Washington Laboratories, Ltd.

RE: Comments of March 21, 2005
APPLICATION: NB5-MB-49-HP YDI Wireless

WLL Project: 8441

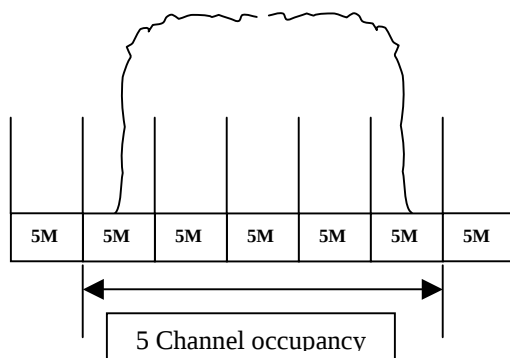
1.) The channel plan of 90.1213 does not appear to be affected. You state in your response that a single channel 20MHz wide at 4965 is utilized. My reading of 90.213 still seems to expect that the center frequency of each emission must fall directly upon the center channel frequencies called out in this table. Please review.

R. We don't agree. The Rules allow for the aggregation of four 5MHz channels to create a 20MHz wide data channel. We submit that the aggregation of Channels 8 through 11 create the 20 MHz wide "channel" that is allowed under the rules. 4965 MHz simply is the center of the four channels.

Hence, our implementation would map out as follows:

To look at it another way, if we set the center of a 20MHz wide channel at the center of one of the 5MHz data channels, the resulting 20 MHz spectrum would fully occupy three 5MHz channels and portions of two other 5MHz channels.

If the center of the emission had to fall in the center of one of the channels, five of the channels would be affected as follows:

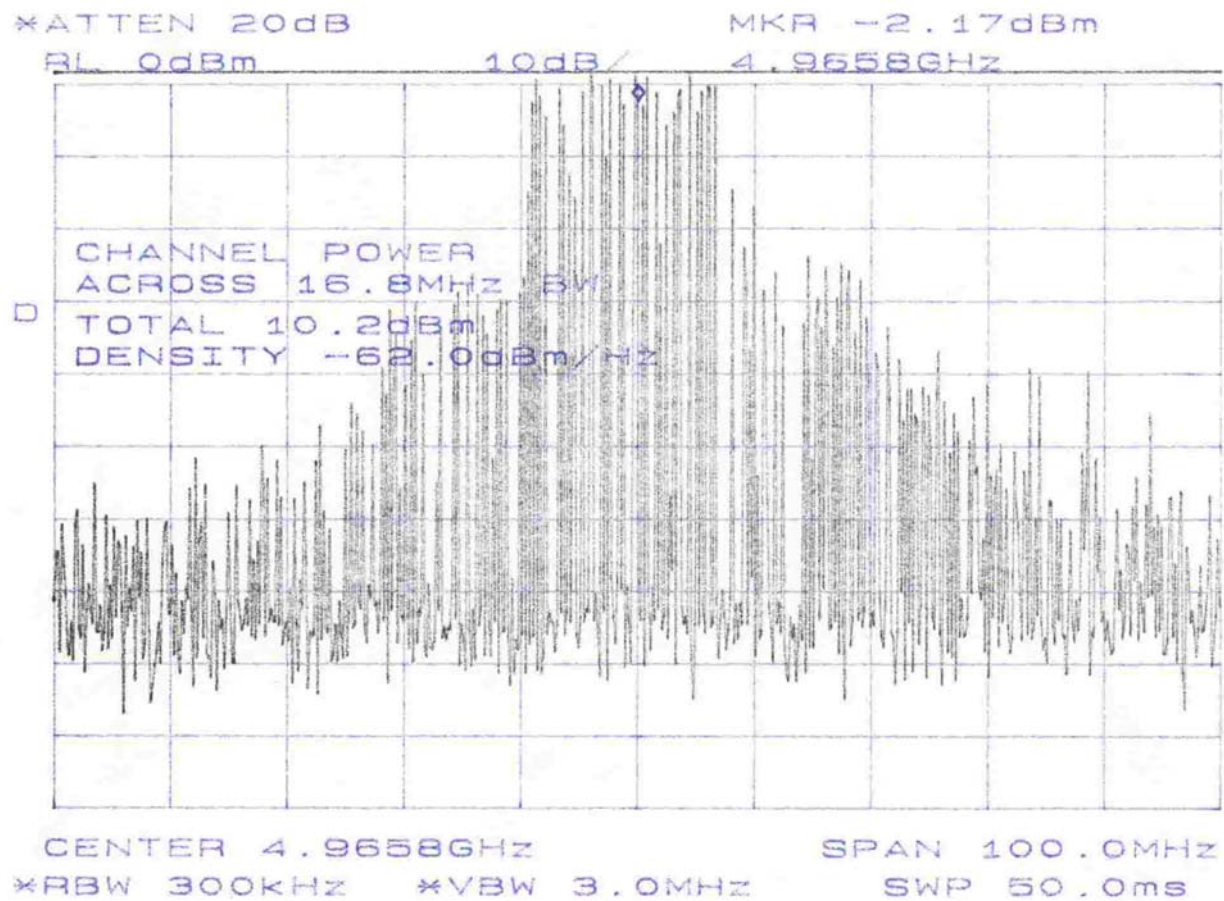
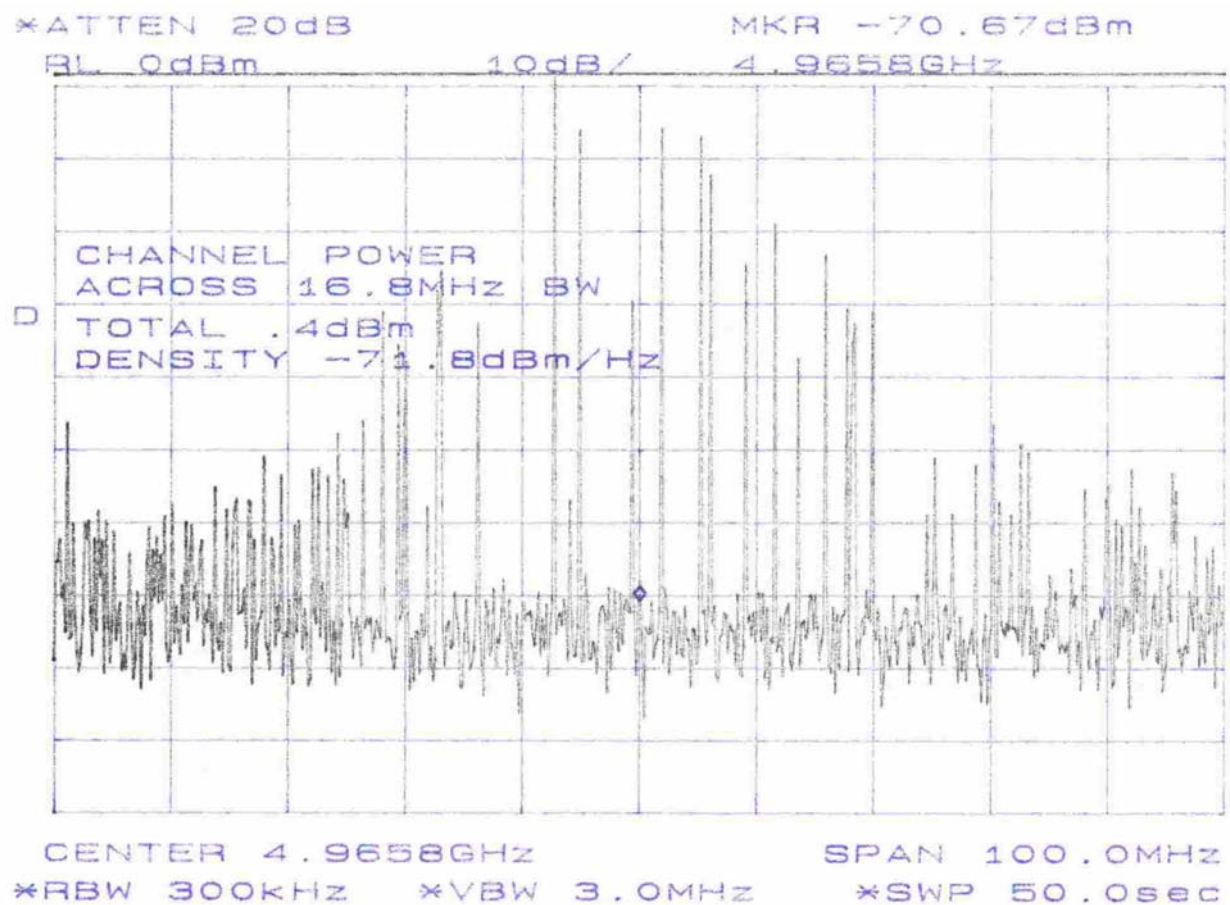
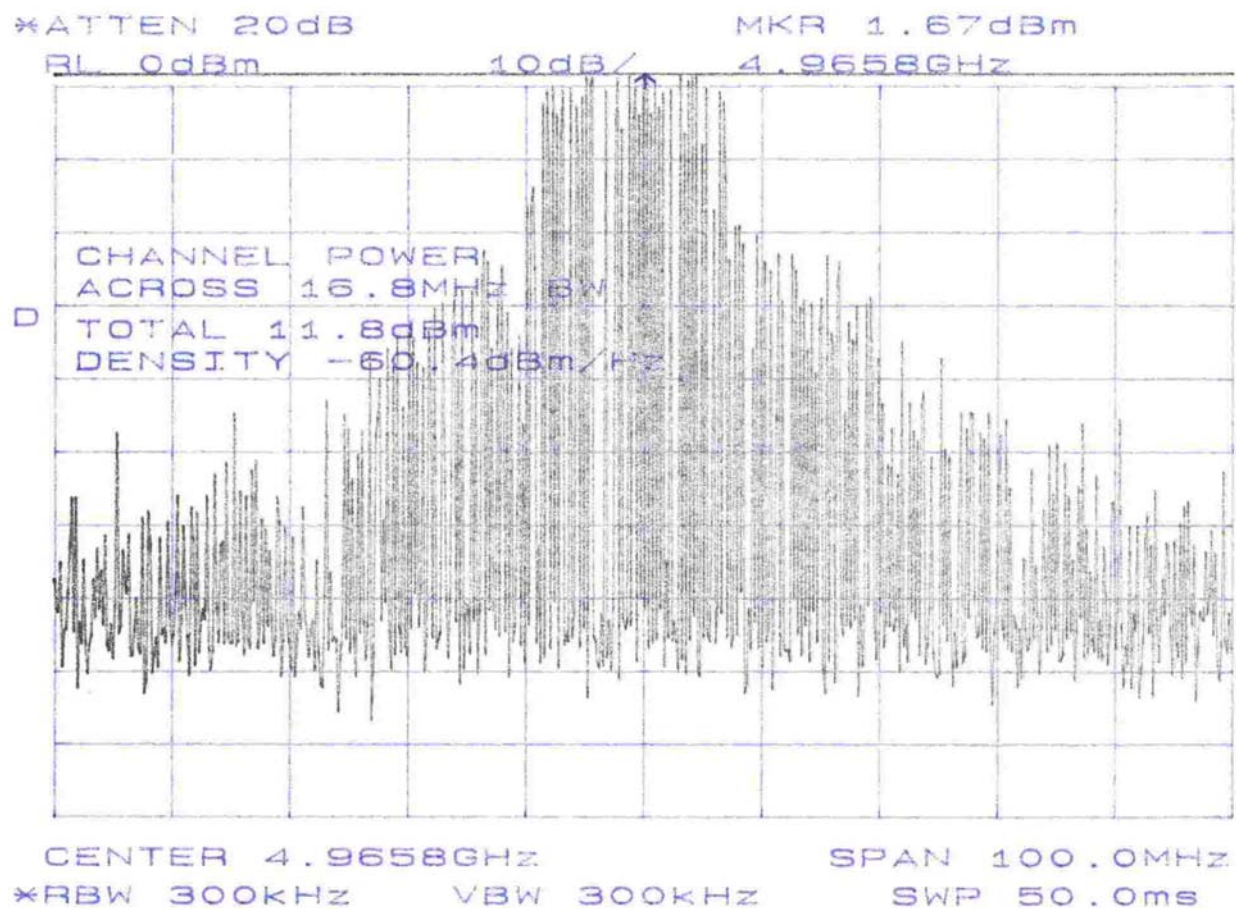
2.) I accept your test method for using the spectrum analyzer RMS detection function of this complex OFDM signal. However, I still have some concerns. Using the instrument manufacturer's explanation, the RMS value is computed for each "bucket" within the trace and then algebraically summed together. Looking at your plot, we do not have a smooth, symmetrical emission; we have a "lumpy" emission characteristic of multi carrier OFDM signals. I would like to know if the measured RMS values are affected by both sweep time and RBW settings. Moreover, using the standard 1% rule, a RBW less than 16.5MHz/100 usually should not be used unless additional explanation is provided. My preference is to know if this RMS measurement would be effected by an RBW of 300KHz or more and a sweep time greater than 50 seconds. Best accuracy is also obtained when the emission is near the top of the reference level due to errors in the log amp. Kindly help me understand the RMS detection function of this instrument. In addition, please confirm that the measurement was made over a "continuous interval" without any periods of "Tx off". Kindly refer to 90.1215(b).

R. Additional plots have been taken. The "lumpy" emission is characteristic of the SAMPLE mode that the analyzer needs to be in to take the correct rms measurement (as directed in the User's Manual for the instrument). MAX HOLDing the signal places it back into Peak mode.

Three plots are provided; the reference level has been adjusted to bring the emission to the top of the screen. In summary, the sweep time affects the channel power a great deal; thus, the channel power is reported with the fastest sweep time. The channel power is nominally the same between this re-measured data and the previously-reported values (10.8dBm vs 10.2dBm).

Plot 1: Channel power with RBW=300kHz and VBW=3MHz; sweep time 50 ms

Plot 2: Channel power with RBW=300kHz and VBW=3MHz; sweep time 50 seconds

Plot 3: Channel power with RBW=300kHz and VBW=300kHz; sweep time 50 ms

PLOT #1: Channel power with RBW=300kHz and VBW=3MHz; sweep time 50 ms

Plot 2: Channel power with RBW=300kHz and VBW=3MHz; sweep time 50 seconds

Plot 3: Channel power with RBW=300kHz and VBW=300kHz; sweep time 50 ms
